MONTICELLO NUCLEAR GENERATING PLANT

AMENDMENT TO FACILITY OPERATING LICENSE

Amendment No. 57  
License No. DPR-22

Attachment:  
Changes to the Technical  
Specifications

Figure 3.4-1 Sodium Pentaborate Solution Volume Concentration Requirements

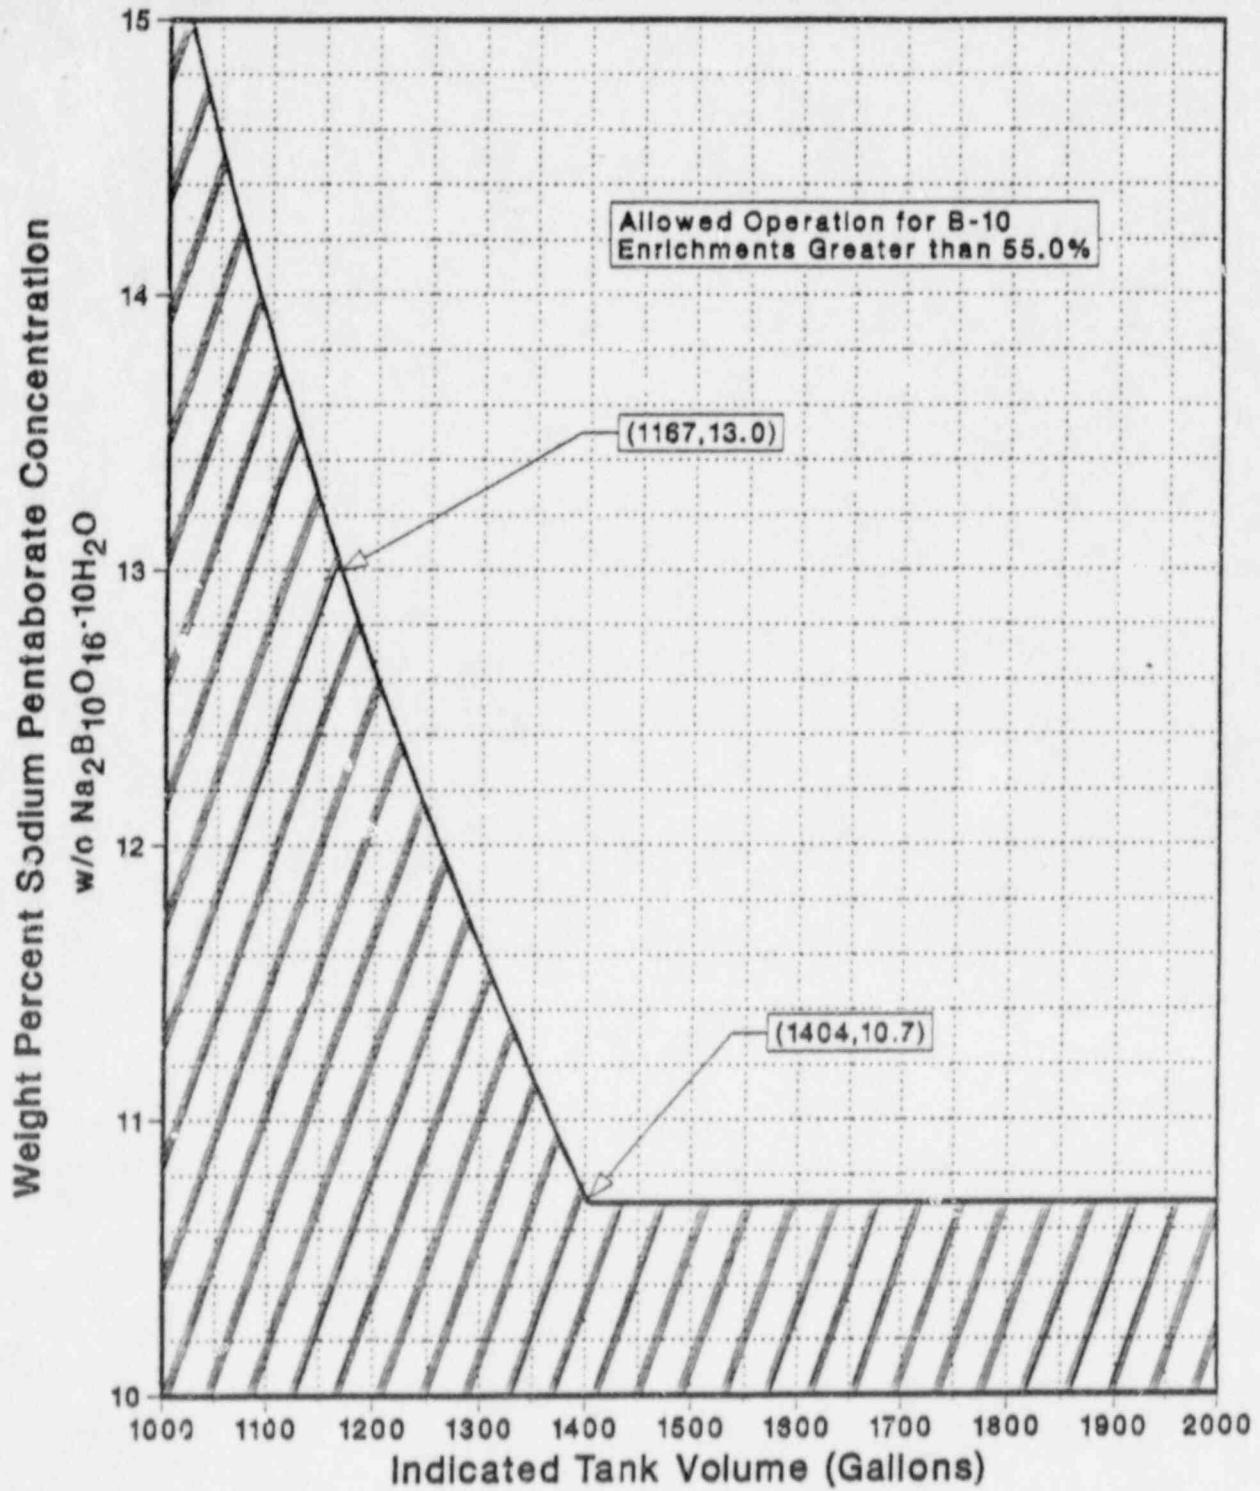
1. The liquid poison tank shall contain a boron bearing solution that satisfies the volume, concentration and enrichment requirements of Figure 3.4.1, or compliance can be demonstrated by satisfying the following equations:

$$V \geq \left( \frac{71.18}{0.0051x_C + 0.998} \right) \left( 1 + \frac{4821}{1101-E} \right) \left( \frac{19.8}{E} \right) \left( \frac{100}{C} \right) + 128 \text{ gal}$$

$$C \geq 8.28 \left( \frac{86}{Q} \right) \left( \frac{19.8}{E} \right)$$

- V - indicated Boron solution tank volume (gal)
- x - measured Boron solution enrichment (atom%)
- C - measured Boron solution concentration (wt%)
- Q - measured pump flow rate (gpm) at 1275 psig
